North Hertfordshire District Council

Building Conservation comments

File Ref: 24/02291/FPH & 24/02292/LBC

Subject: Two storey rear extension with solar roof panels, following demolition of existing conservatory, existing single storey rear extension and two rear dormer windows, and internal alterations.

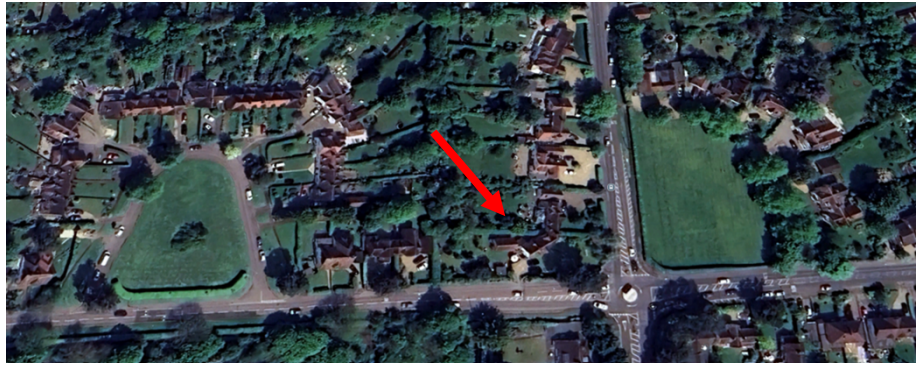
- 2.3 It is useful to note that when commenting on a rear conservatory following demolition of existing (as amended by plan received on 25 January 2007) under refs: 06/02322/1HH and 06/02324/1LB (photo below taken at the time), the Conservation Officer wrote:

However, a conservatory structure would be the only form of addition in this position that would be considered as not being detrimental to the character of this building. It would ensure the original cottage form to be clearly seen through the glazed structure. It is therefore considered that the retention of solid walls would compromise the appearance of the listed structure and are not acceptable.
